## Memorandum of Findings

**Project:** Wilson Drive, Narragansett:  
Proposed Single-Family Dwelling

**Re:** Memorandum of Findings  
CRMC File No. 2022-12-075

**PROPOSED HIGH-WATER PROFILE**

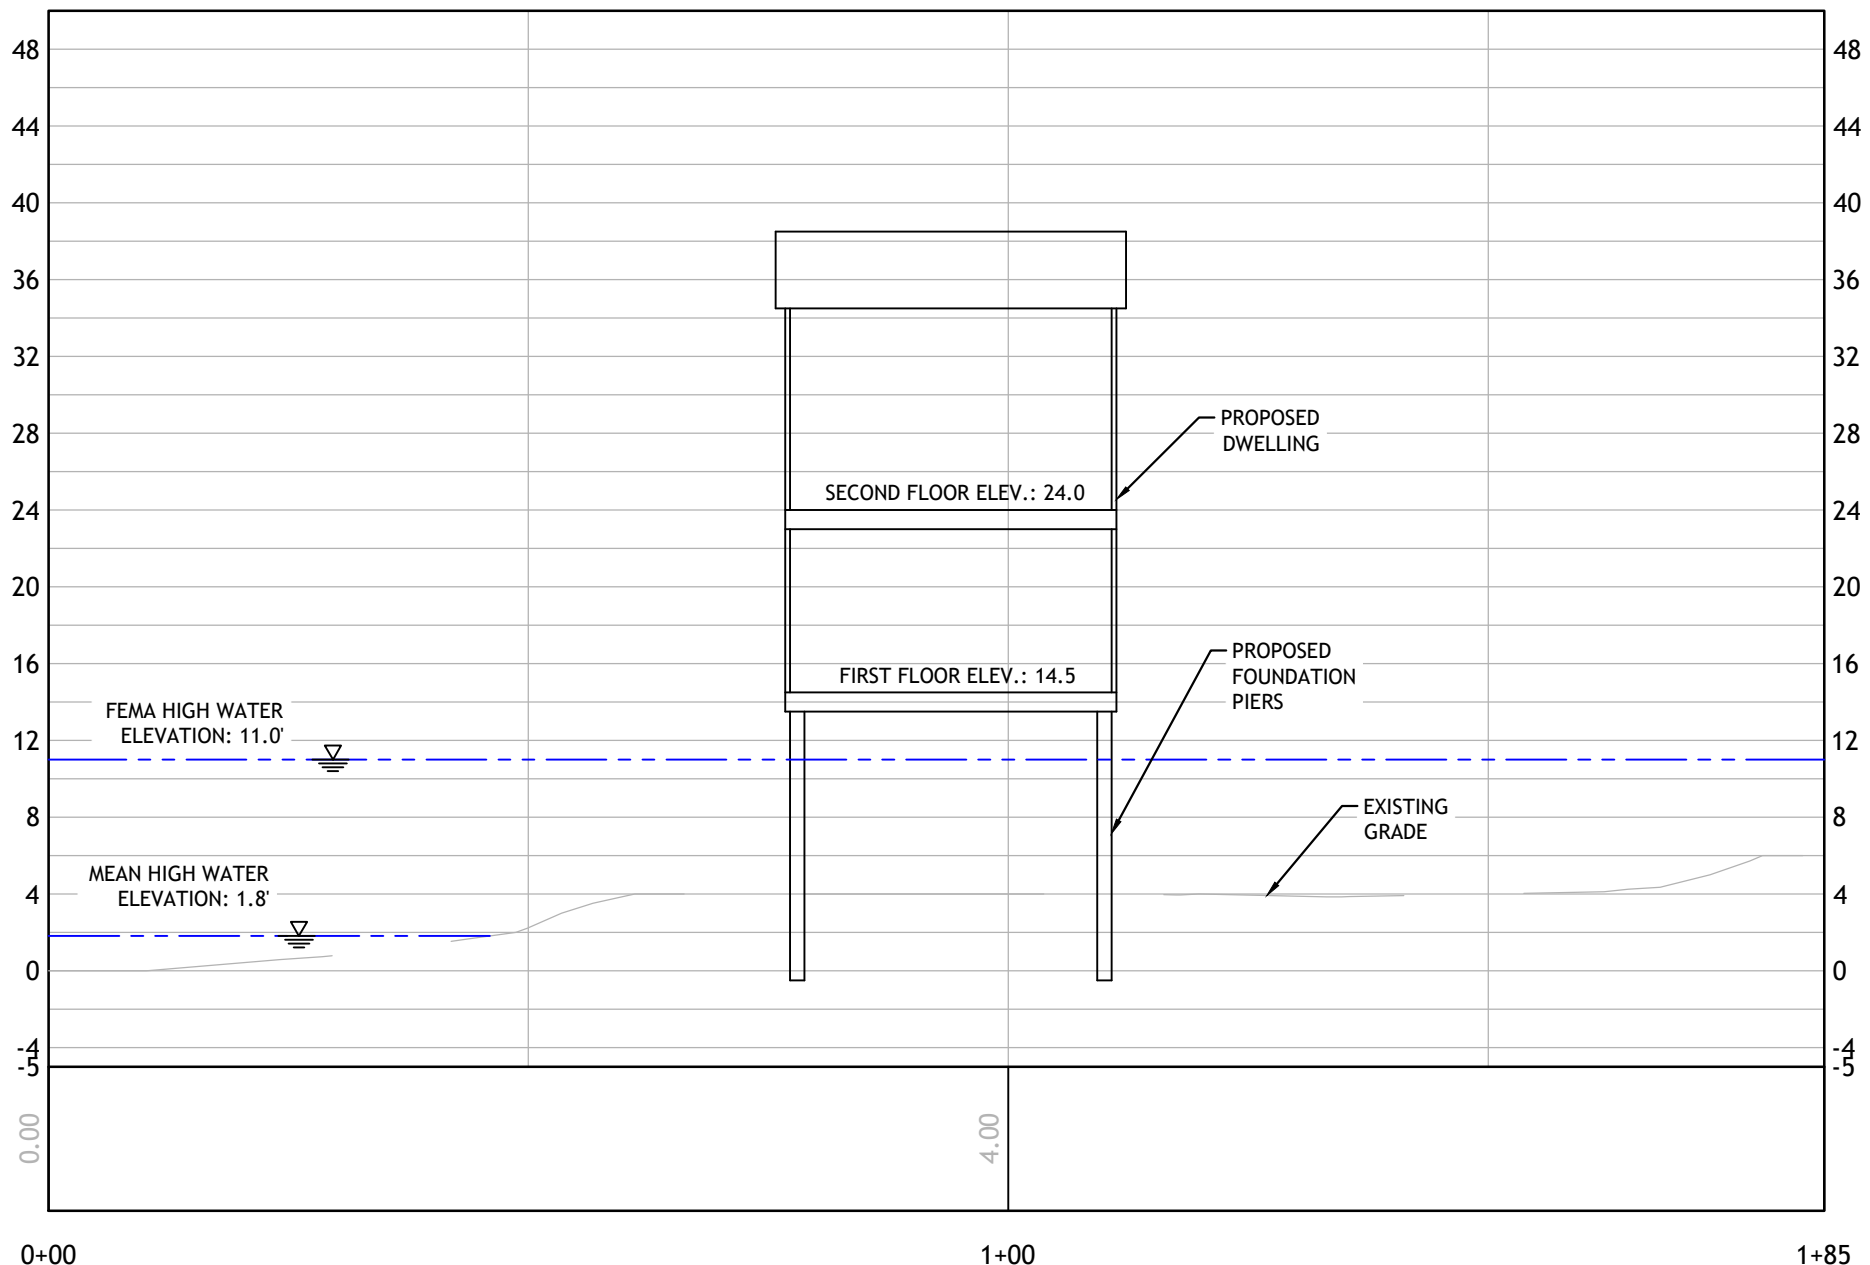
*Comment 3: -- Section 1.1.7(A)(3) states that "due to conditions at the site, the applicable standard(s) cannot be met". Staff concurs with this statement, as the substandard lot zoned R10) predates the Council and is half wetland. It is staff's opinion that the lot has remained undeveloped for decades due to the difficulty in meeting the required standards as well as due to the existing lot conditions (increased flooding).*

The parcel is a legal, non-conforming lot of record with development rights. The project complies with the minimum building requirements for FEMA and local building codes. Flooding will occur within this site with or without this project as the flood storage will be the same under pre- and post-conditions. JCE has created a Proposed High-Water Profile to depict how the proposed single-family dwelling will be affected by the mean high-water elevation (El. 1.8 feet) and the FEMA [100-year flood] elevation (El. 11 feet). The first-floor elevation is set at 14.5 feet. This is 10.5 feet above ground level and 3.5 feet above the AE Flood Zone elevation of 11 feet. Under this scenario, the neighboring properties would be inundated with flood water. Please refer to Exhibit B for the Proposed High-Water Profile.

The 14.5-foot elevation also exceeds the STORMTOOLS Design Elevation (SDE) for a predicted 1.47 feet of sea level rise (SDE = 13.9 feet). The SDE for 3 feet of sea level rise would be 17.4 feet. This is 6.4 feet above the current AE Flood Zone and would not be consistent with current building code minimums. The 14.5-foot elevation, while not accommodating the full 3-foot SDE, is consistent with the CRMP's policies pursuant to Section 1.1.10 and application requirements from Section 1.1.6.

As shown in the attached Proposed High-Water Profile, the proposed single-family dwelling's first-floor elevation is set at 14.5 feet; 10.5 feet above ground level and 3.5 feet above the FEMA AE Flood Zone elevation of 11 feet which is in compliance with current FEMA minimum construction requirements and State Building Code. The 14.5-foot elevation also exceeds the STORMTOOLS Design Elevation (SDE) for a predicted 1.47 feet of sea level rise (SDE = 13.9 feet).
